# UNITED STATES PATENT AND TRADEMARK OFFICE

APPLICATION NO.	FILING DATE	FIRST NAMED INVENTOR	ATTORNEY DOCKET NO.	CONFIRMATION NO.
10/766,789	01/27/2004	Michael J. Cusick	OSTEONICS 3.0-449	4013

**Office Action Summary**

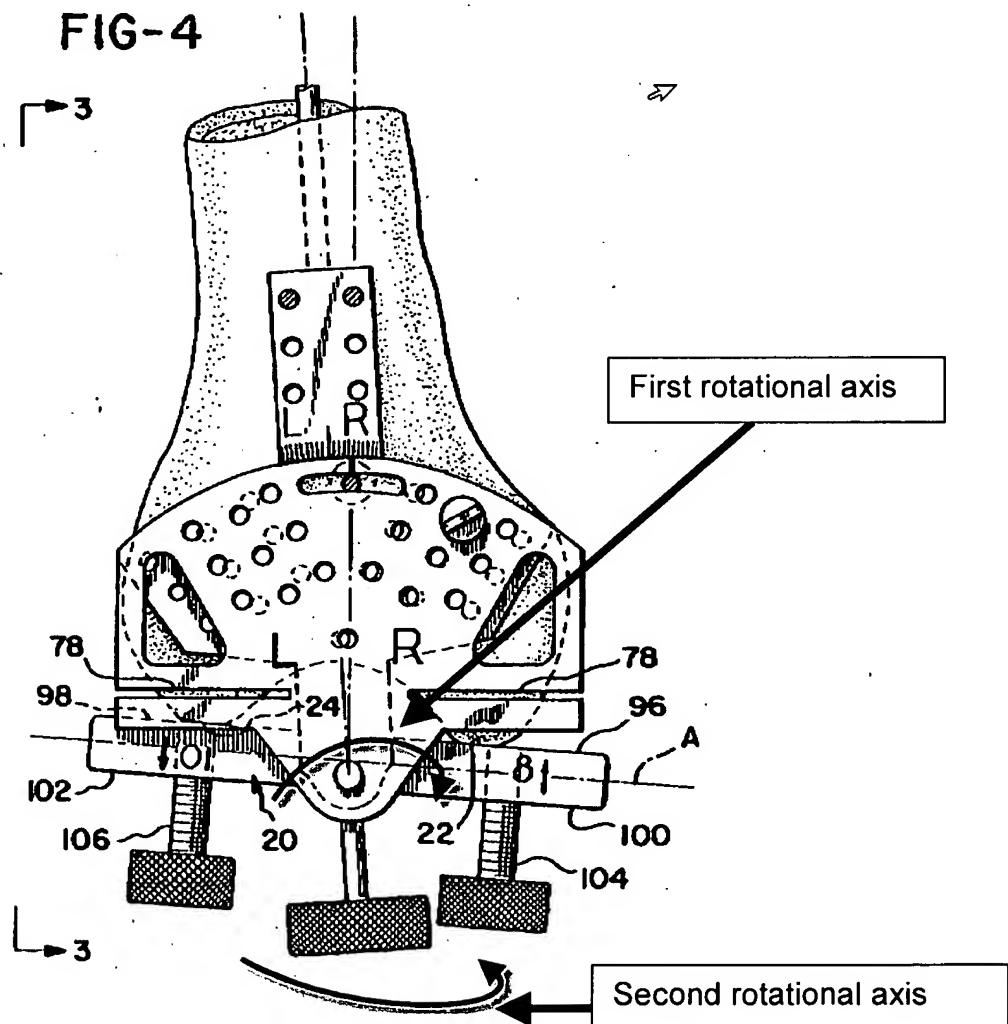
Claims 1-6, 11-18, 23-30, 35-45, 48-51 are rejected under 35 U.S.C. 102(b) as being anticipated by Pohl (US Pat# 4703751). Pohl discloses an apparatus (10) comprising a guide plate (18) and alignment means along a translational path of the rod 14 and/or bolt (62) along the axis of the shaft (34), the device having two rotational paths shown in the figure following this paragraph, being around the boss (44) and the rod (14). The bolt (62) is threaded into the shaft (34) and allows for controlled translation relative to the guide, being a first assembly. The second assembly (14) allows for

rotation about a first rotational path in controlled increments by turning the knob (32) in relation to the rod (14) and the device (10). The third assembly of the fan shaped portion (40) with the cutting plate (18) and the shaft (34) and boss (44) allow for controlled rotation about a second rotational axis in controlled increments affected by gear/bolt (86, 88), additionally, the boss being a releasably coupling agent of the guide. The assembly of the cutting plate (18) is considered the housing as it houses the fan portion (40), which is a rotatable plate. The first assembly of the bolt (62) also comprises the yoke, which consists of the two spaced apart bars (104, 106) which are transversely threaded rods for slidably coupling the yoke cross-member bar (20), where rotation of bolt (62), a threaded rod, allows for translation of the yoke relative the rest of the assemblies, where when the bolt 62 is fully threaded into the shaft, further rotation will cause the guide plate (40) to rotate, where this guide has shelf (16) having openings (54). The fixation plate (40) is pivotally coupled to the rod of the yoke through the internally threaded shaft (34), which is also a sleeve and rotatably coupled to the guide (18) through the boss (44), and attached to the first guide/plate portion (40) where rotation of the sleeve will cause rotation of the portion (40). The guide plate (18) has slots (78) for an instrument. The rotational paths and location of the apparatus components may become fixed upon termination of the operation of the appropriate assemblies. For the purposes of claim 37 and its dependencies the screws (86) and the slot (66) it interacts with will be considered interacting gears, the threads of the first gear (86) will spin against the wall of slot (66), being an arcuate opening, with will be the interaction of the gear-like portion of the fan-shaped element (40), upon spinning the

screw (86) within the base hole (68) the threads may interact with the slot (86) such that they may affect a slight movement of the plate in on rotation path. The apparatus is designed for use within the angles of the valgus (column 5, lines 7-16). The plate portion (40) is fixed to the bone via the drill bit (56) through one of the holes (54) (column 6, lines 64-68).
